**Statement of Response to ABP's Pre-Application
Opinion under ABP Ref.: 311958-21**

Proposed Strategic Housing Development

Ballyoulster, Celbridge, Co. Kildare

Client:	Kieran Curtin, Receiver over certain assets of Maplewood Developments Unlimited Company (in liquidation and in receivership)
Project Title:	Ballyoulster SHD (Phase 1)
JSA Ref:	(JN20114)
Document Title:	Statement of Response to ABP's Opinion

Figure 1: Flood Extents Map – Present Day and Climate Change Scenarios (Source: SSFRA)

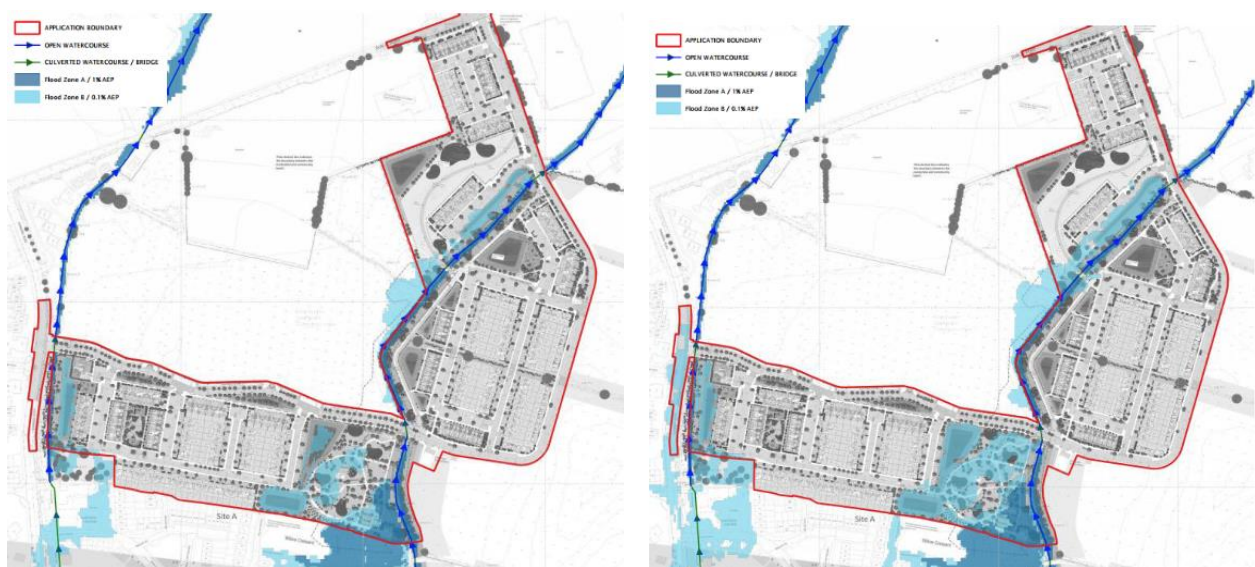
“1. Further consideration of, and possible amendment to the drawings and design proposals submitted, having regard to the findings of the Hazelhatch Flood Extents Study 2021 (KCC) and the impacts on the layout and extent of development proposed on the site. A revised Site-Specific Flood Risk Assessment should accompany the application which has full regard to the provisions of the Planning System and Flood Risk Management Guidelines for Planning Authorities in this regard.”

In response to this item, a Site Specific Flood Risk Assessment (SSFRA) prepared by McCloy Consulting is submitted with the application and has informed the final scheme layout and design. In order to address the findings of the Hazelhatch Flood Extents Study 2021 (KCC) and subsequently the results of the SSFRA, the proposed layout has been revised following the pre-application stage in response to the above request. A detailed response on how the flood risk assessment has impacted on the layout and the extent of development proposed on the site, in

To facilitate a better understanding of flood risk at the site and to inform the final scheme layout and design, detailed hydraulic modelling was undertaken by McCloy Consulting and is summarised in the SSFRA. The SSFRA has been prepared in accordance with the requirements of the Planning System and Flood Risk Management – Guidelines for Planning Authorities (2009) and confirms a portion of the site at the southern side is located within Flood Zone A and Flood Zone B (primarily located in Site A, extending along the Shinkeen Stream north and into Site B) with the remainder of the site in Flood Zone C.

As a result of the updated flooding information, as discussed further below, the development proposals have been significantly revised following the pre-application stage to ensure the proposals are developed in accordance with the Flood Zones on the site. The proposed residential development, the childcare facility and the proposed pumping station are located within Flood Zone C, whilst part of the access road, streets, parking and open space are located partly in Flood Zone's A and B. The proposed development is considered compliant with the Planning System and Flood Risk Management Guidelines, noting the development proposals for the site have been developed in accordance with the sequential approach to flood risk management to ensure that the proposed development is sited in appropriate flood zones, having regard to the classification of vulnerability of different land uses and types of development. The SSFRA report outlines there is no loss of floodplain and therefore compensatory measures are not required. The

Figure 3: Extract Land Use Zoning Objectives Map

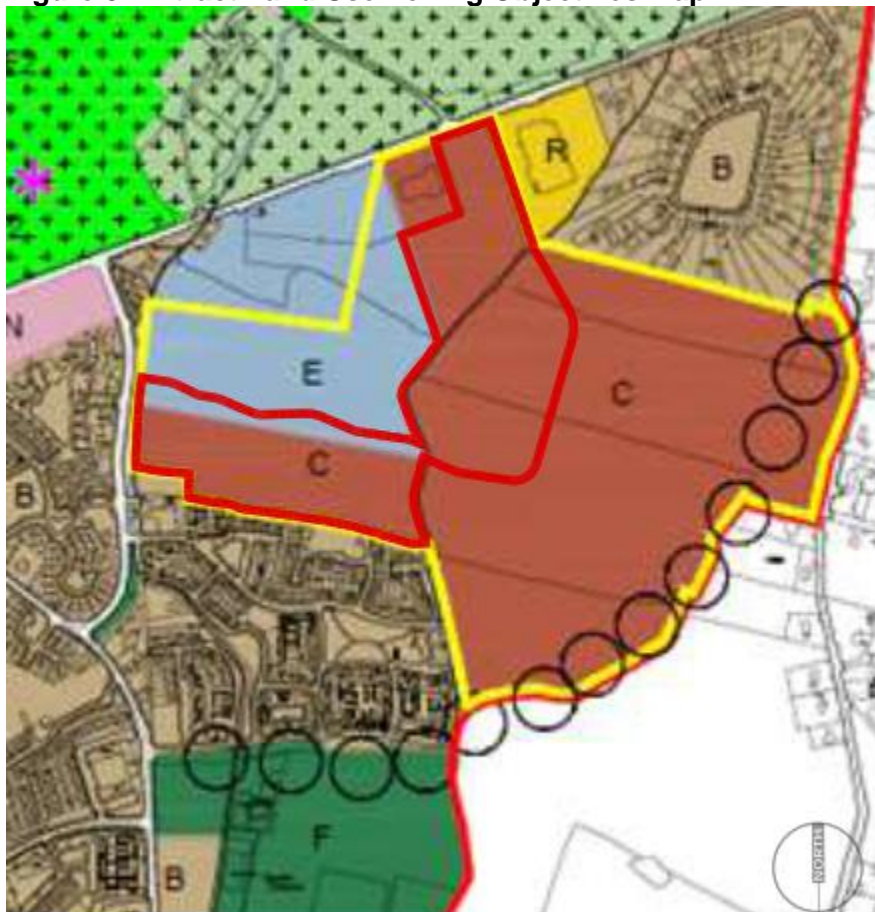
***“2. Further consideration of the documents submitted, to include a detailed statement of consistency and planning rationale, clearly outlining how in the prospective applicant's opinion, the proposed development complies with local planning policy, having specific regard to the zoning of part of the proposed development site as objective E: Community & Educational. Such statement should have regard to the definition of Strategic Housing Development under section 3 of the Planning and Development (Housing) & Residential Tenancies Act 2016, and section 9(6)(b) of the Act which provides that the Board shall not grant permission where the proposed development, or a part of it, contravenes materially the development plan or local area plan relating to the area concerned, in relation to the zoning of the land.*”**

The application site is primarily zoned 'C: New Residential' which seeks 'to provide for new residential development' and partly 'E: Community and Educational' with the objective 'to provide for education, recreation, community and health'. The lands are identified within the Celbridge Local Area Plan 2017-2023 as part of a key development area 'KDA 2 Ballyoulster'.

As discussed below, the proposed development is consistent with the Celbridge LAP Land Use Zoning Objectives Map and the Land Use Zoning Matrix set out in section 13.4 of the LAP.

Figure 6: Proposed Phasing

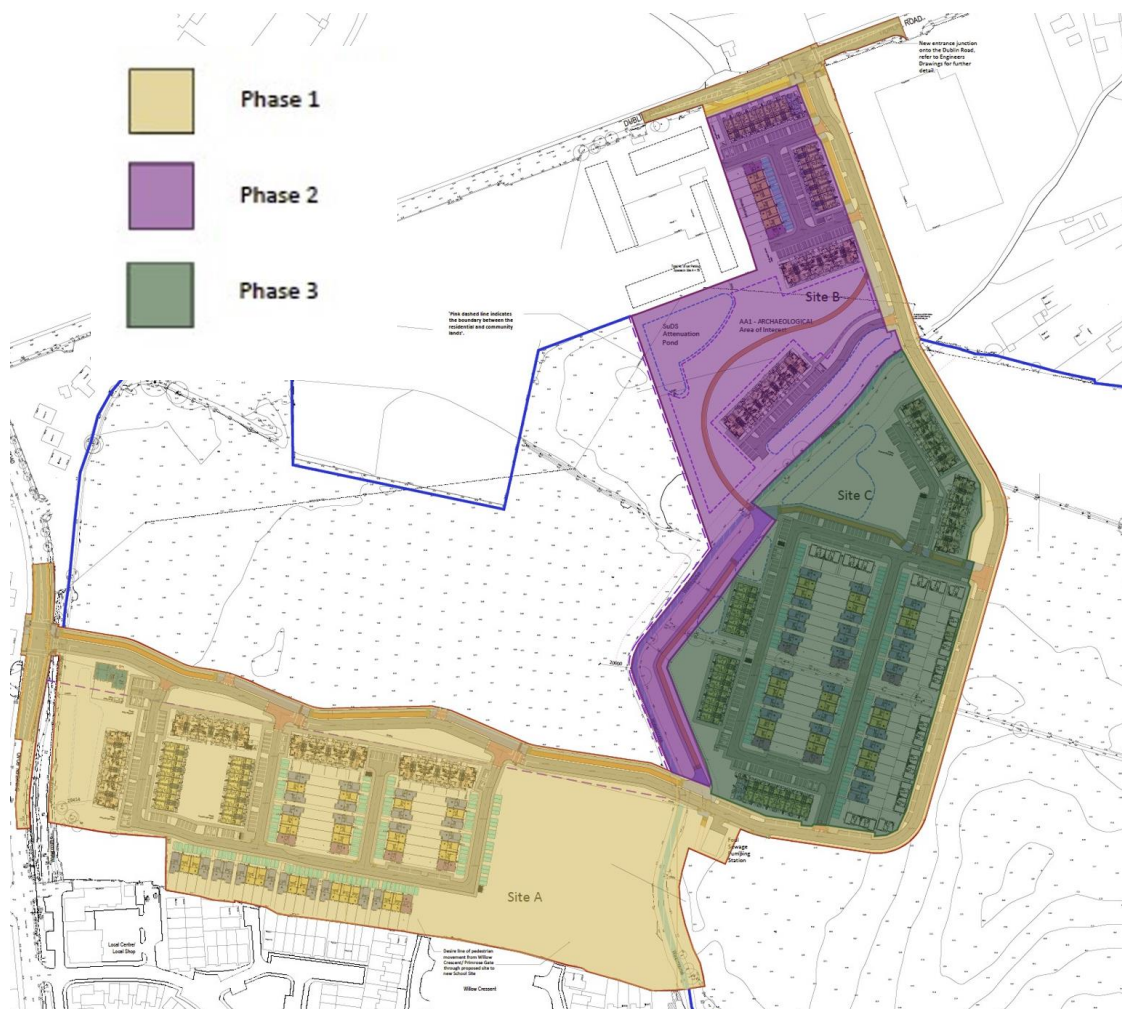
- 1. Detailed phasing proposals for the development which should include all associated road and infrastructure works, public amenity spaces and social infrastructure. The proposed phasing strategy shall address the extent of landscaping works to be undertaken within the Local Park in each phase and its on-going maintenance pending further development within the KDA.***

We refer to the architectural drawing no. 20007-OMP-ZZ-PH-DR-A-1009 'Proposed Construction Phasing Plan', the Design Statement prepared by OMP and the Infrastructure Design Report prepared by DBFL which provides details of the proposed phasing of development on the subject site. In summary, the proposed construction of the development has been split into three number distinct phases over a 5-year construction programme as per Figure 6 and Table 1 below.

It is proposed that Site A (131 residential units and the childcare facility) along with the local distributor road linking the Shinkeen and Dublin Road would be developed first. This would include the 3 number bridge crossings over the Shinkeen and Hazelhatch watercourses, the foul pumping station and associated infrastructure and the junction upgrades. During this period, it is anticipated that any field works in the area of archaeological interest would be undertaken. It is proposed this would be over a 24-month programme. This is aligned with the Irish Water upgrade works, including the Primrose Hill gravity sewer project which is due to be delivered by 2025. This would align with the delivery of the first phase of units on the subject lands, assuming grant of permission by Q4 2022 / Q1 2023, with the 6 month pre-construction phase to commence in 2023, followed by an 18 month construction time frame over 2023 to the end of 2024. First occupation in 2025 aligns with the completion of the Irish Water upgrade works.

Phase 2 would consist of all housing units and associated infrastructure within Site B (71 residential units) and would include the pedestrian and cycle links along the riparian strip which join Sites A and B respectively. It is anticipated this would be over a 12-month programme.

The final phase (Phase 3) will consist of all housing and infrastructure works associated with Site C (142 residential units) and would be anticipated to be completed over a 24-month programme.

Figure 7: Extract Site Layout Plan Potential Future Connection

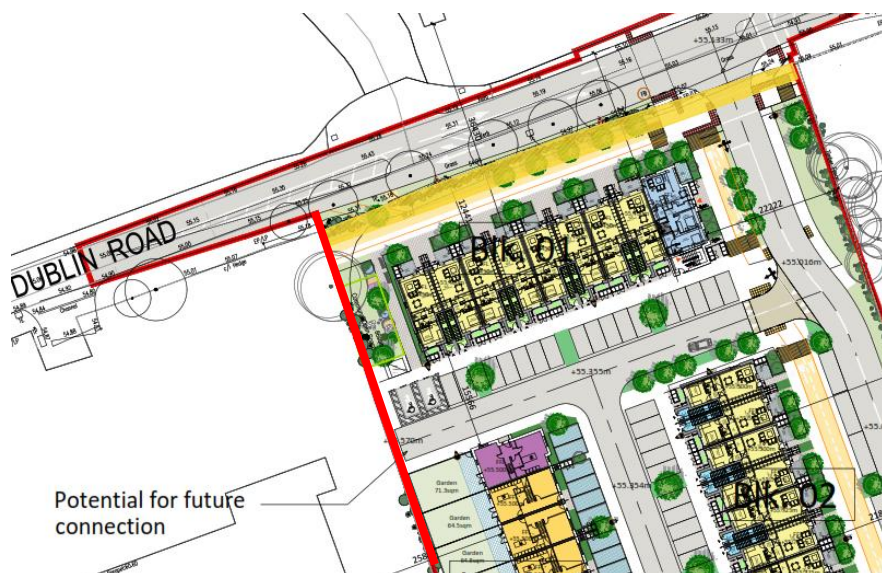
5. Plans and details describing how the proposed development provides for, and will relate to, potential future development of residentially zoned third-party lands along the Dublin Road frontage, within the Ballyoulster KDA 2.

The site layout plan includes internal roads, cycle paths, footpaths, with proposed infrastructure and access points provided up to the application site boundary to facilitate potential future connections to adjoining lands, including the potential future development of the residentially zoned third party lands along the Dublin Road frontage.

We also refer to Section 2.4 of the Design Statement prepared by OMP which has undertaken a feasibility study to demonstrate that the proposed development has been designed to ensure it does not prejudice the provision of vehicular or pedestrian access or key infrastructural services to adjoining lands.
